Rename Majestic Commercenter Building #16

BUILDING 16

BUILDING 16
MAJESTIC COMMERCENTER FILING NO. 13
COVER SHEET

MAJESTIC PHASE 10 BLDG 16 SUBARU
MAJESTIC COMMERCE CENTER FILING NO. 10
FINAL LANDSCAPE PLAN

SITE PLAN

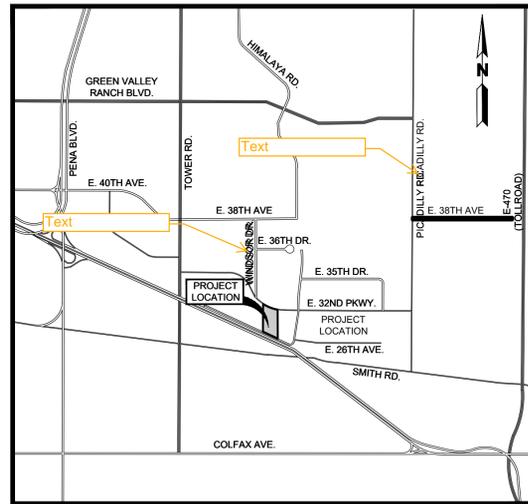
The site plan will not be approved by public works until the preliminary drainage letter/report is approved

Provide a lighting/photometric plan for site. See FDP for lighting requirements.

Please provide correct breakdown for parking per UDO:

Please place correct zoning which is I-1. Business/Tech District

Per the 2015 IBC table 1106.1 minimum accessible parking spaces is 7 with 2 of them being van accessible. The 2% is for total parking of 501 to 1,000 spaces.

Please provide additional signage info as shown. Max area is 600 sf. The max # of signs is 5.

SHEET
L2
Sheet of

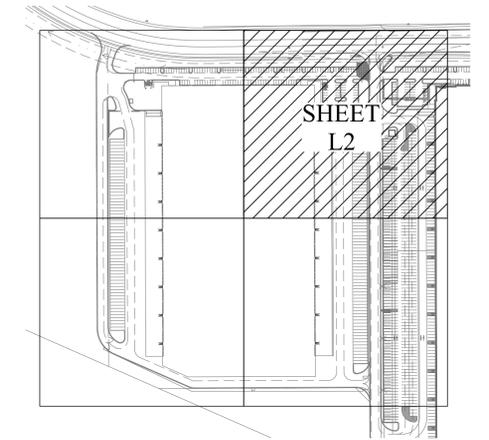
Add a tree here
COMPLETED

Turn off the drainage arrows from the existing grading
COMPLETED

What is going on here with the rock mulch in the drive aisle?
COMPLETED

What are the heavy dark lines
COMPLETED

Double row of shrubs needed here to screen parking lots.
COMPLETED

Provide an additional landscaped parking lot island
NOT COMPLETE. FURTHER DISCUSSION WITH COA NEEDED.

This area is different on the site plan.
COMPLETED

match the plat name for the easement
COMPLETED
